**AGENDA**  
**HISTORIC PRESERVATION BOARD**  
City Commission Chambers  
October 26, 2023 8:30 A.M.

**AGENDA**  
**DESIGN REVIEW COMMITTEE**  
October 26, 2023

- B. [HPB23-176 – 1124 Hartsell Avenue](#) – Final Approval requested for the new construction of a single-family house on the vacant subject property. Owner/Applicant: Orbe Construction, Inc.

**ELEVATIONS PLAN**

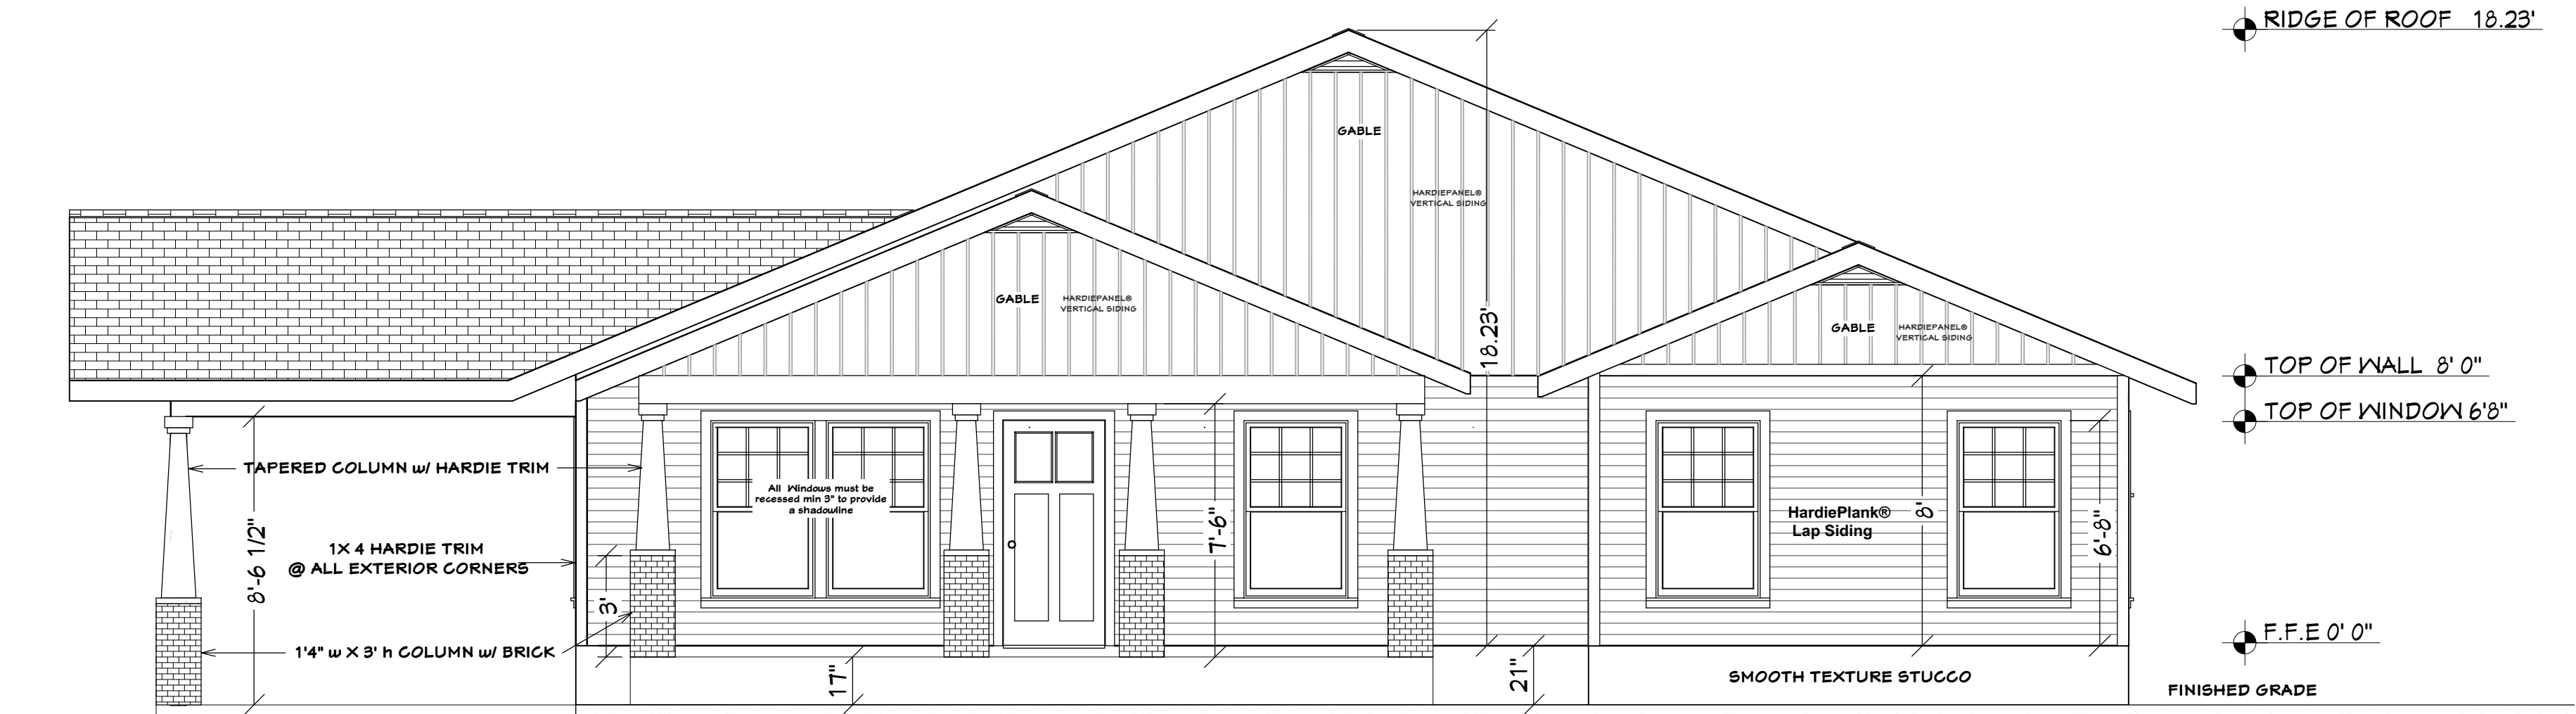
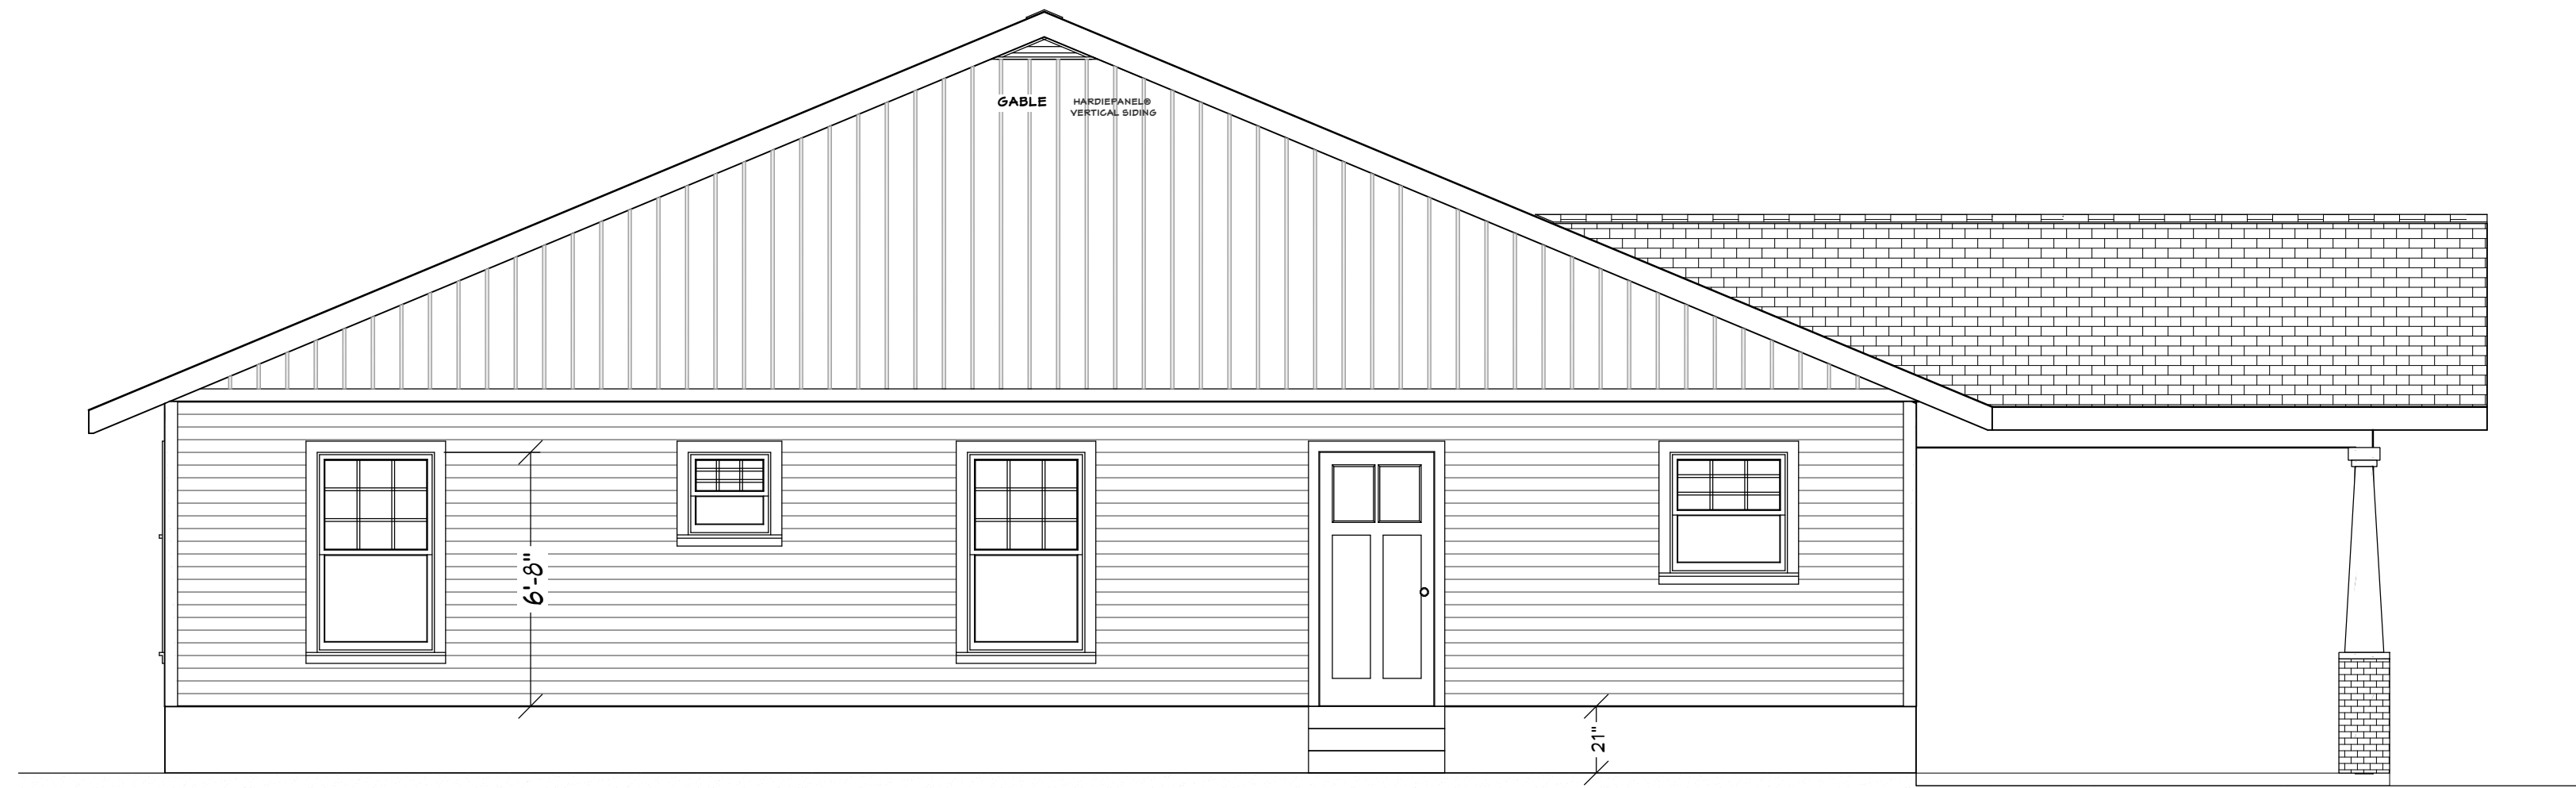
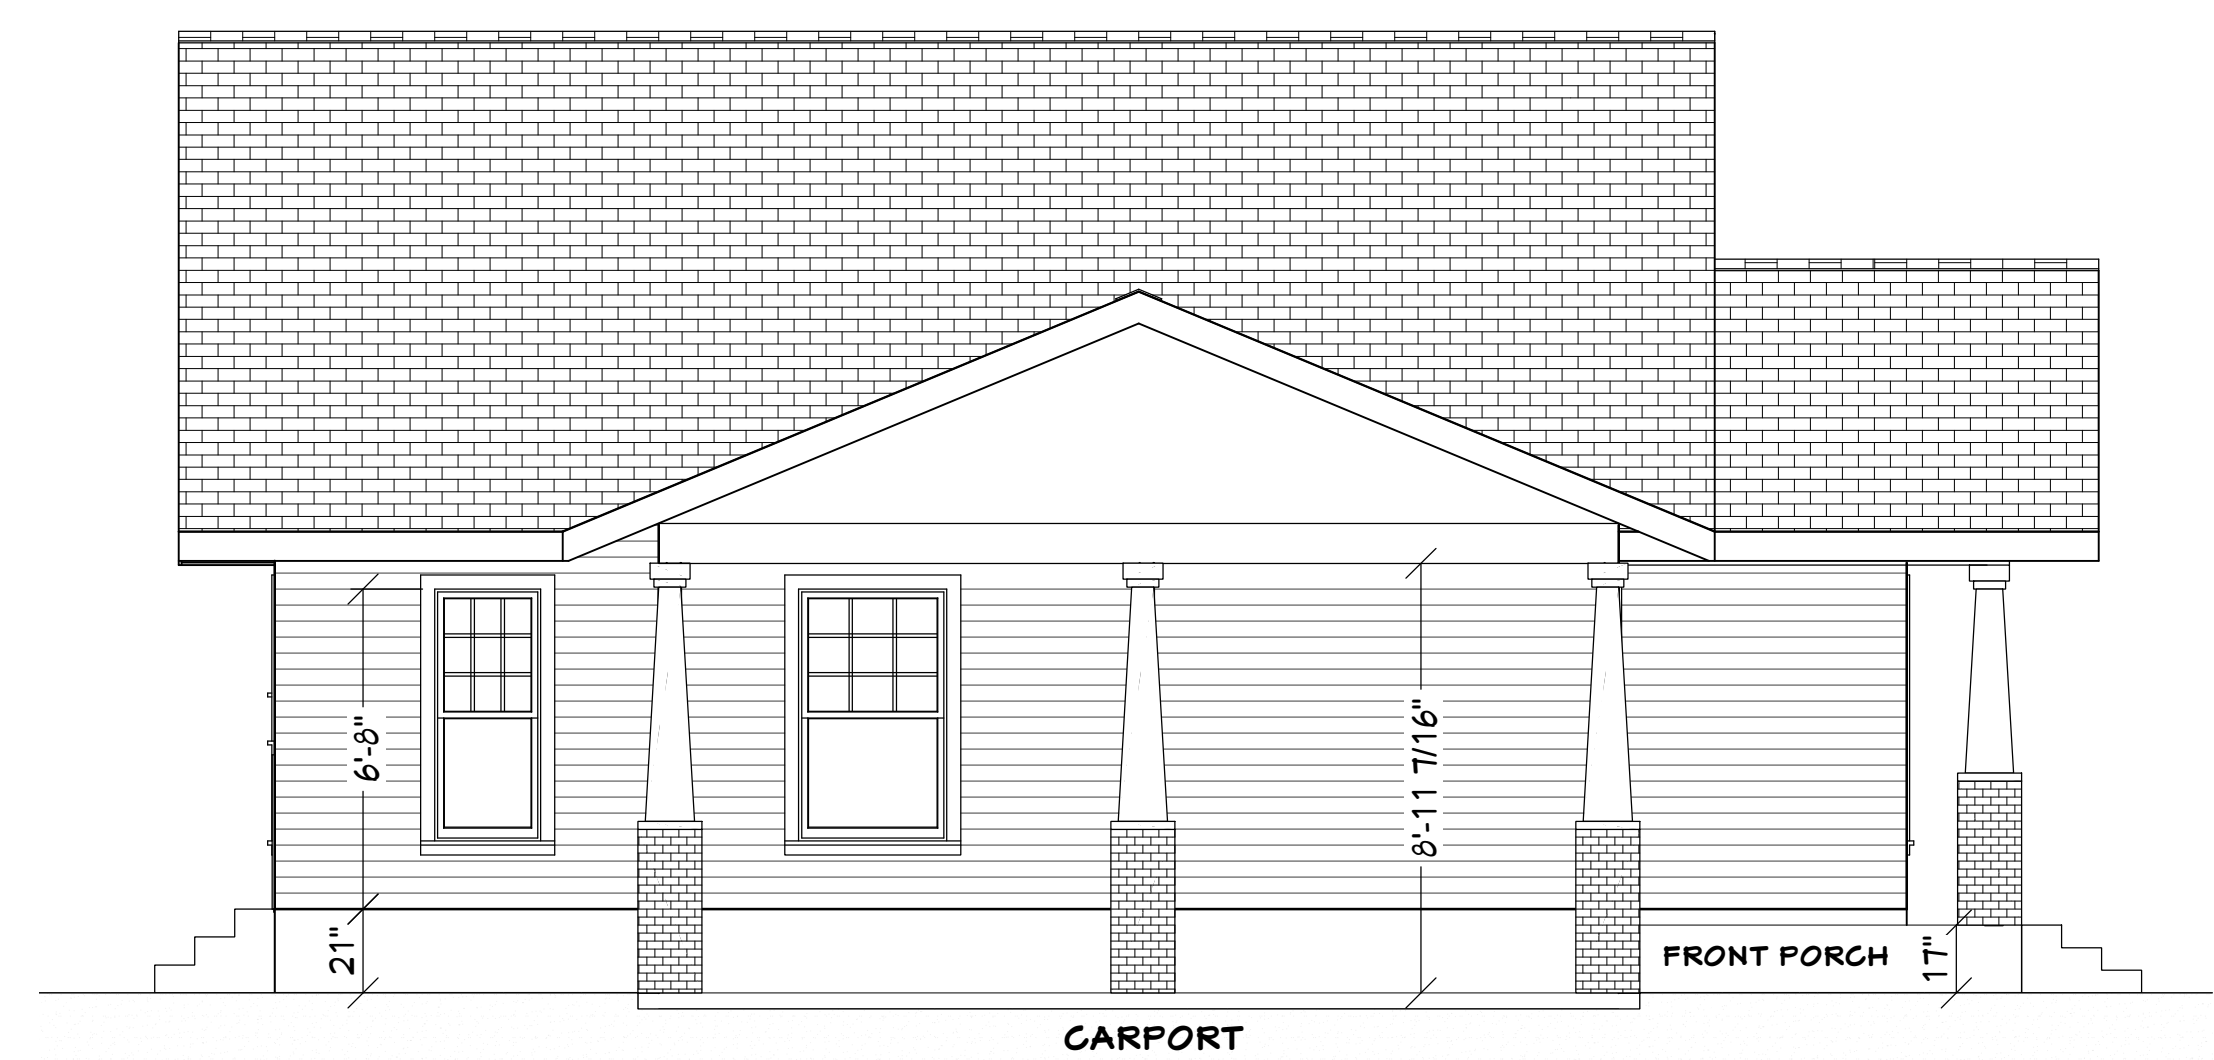
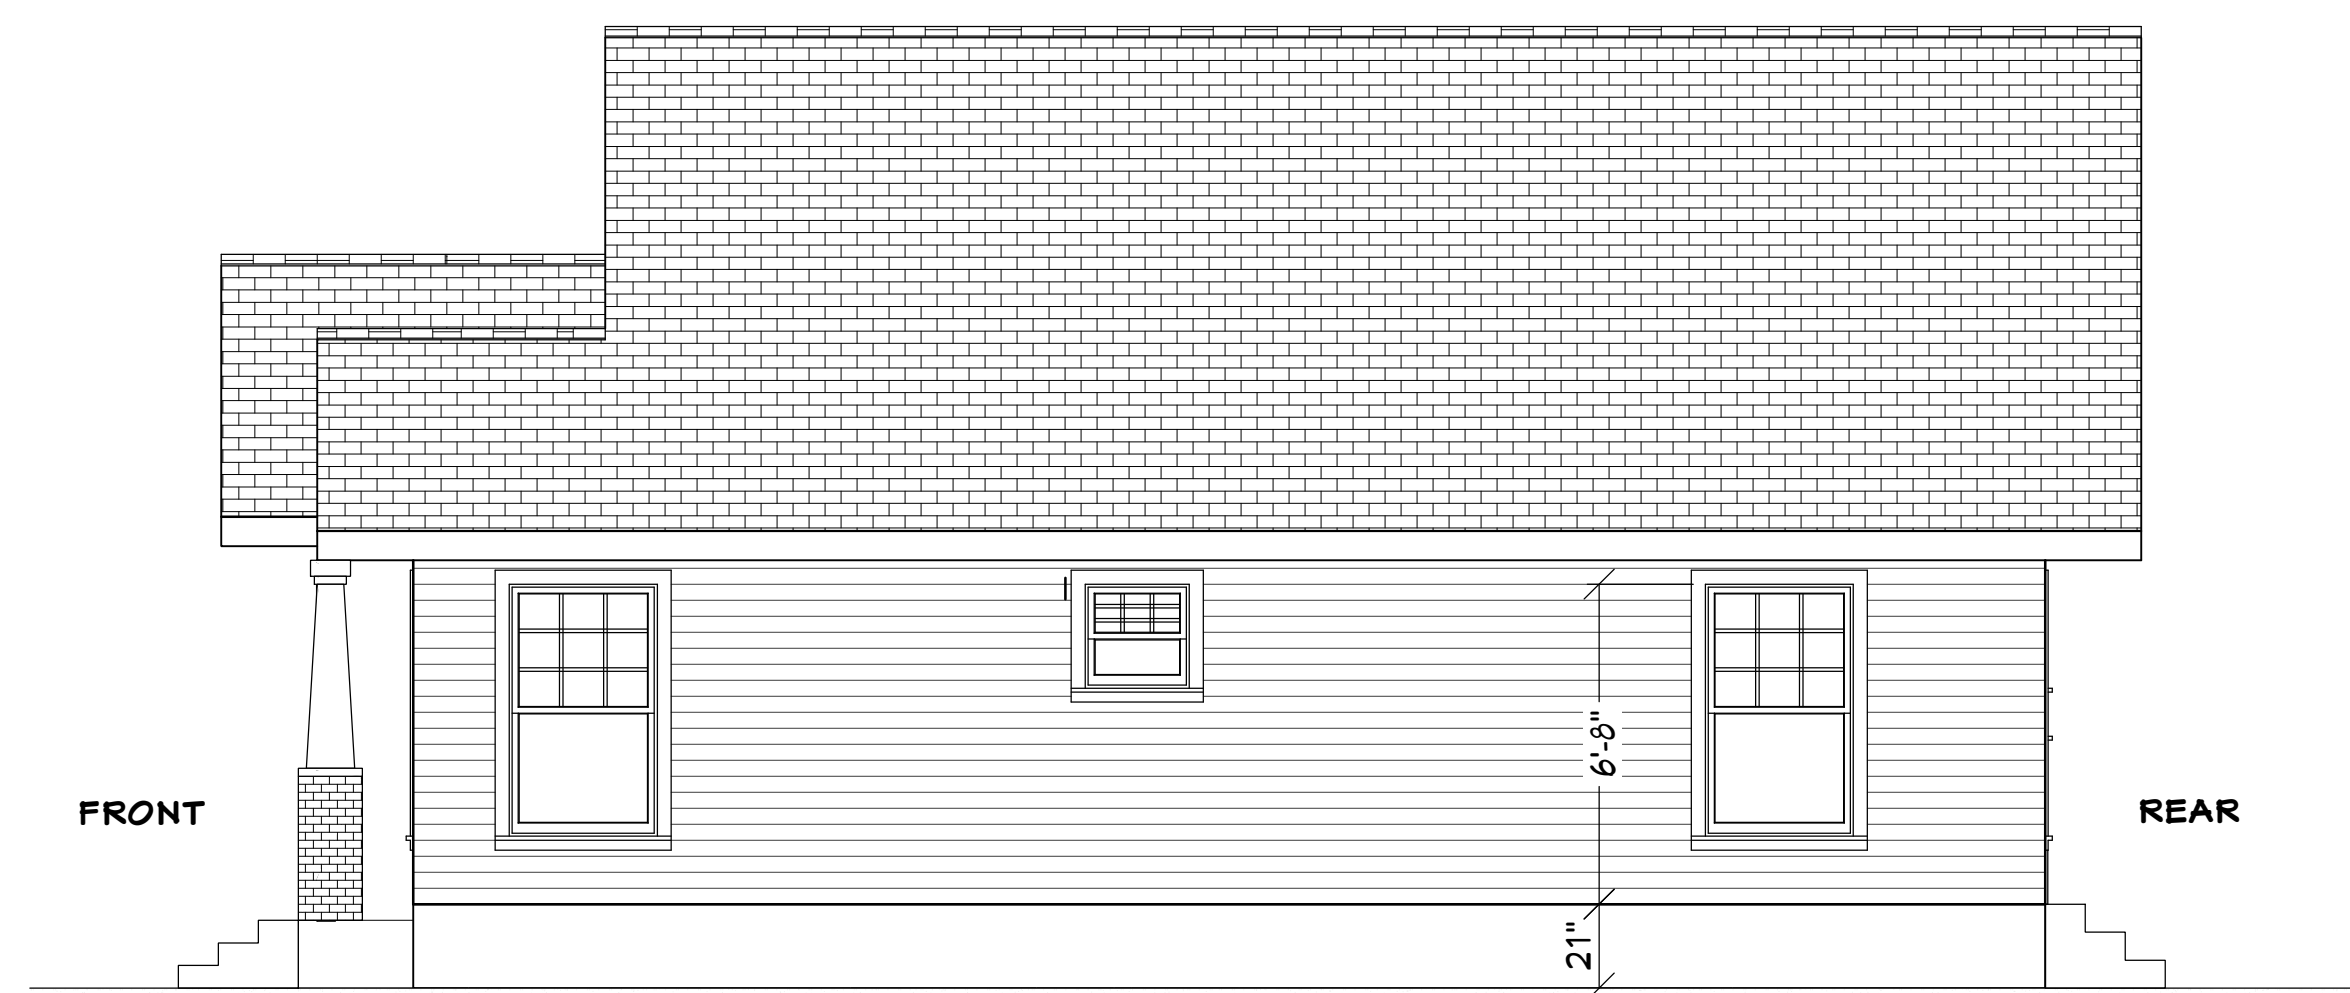
1. Windows must be recessed to provide a shadow line and not installed flush to the exterior wall surface and exterior-mounted muntins/grids are required.
2. Submittal of materials list for fascia, soffit, and exterior doors.
3. Submittal of a complete exterior paint palette.
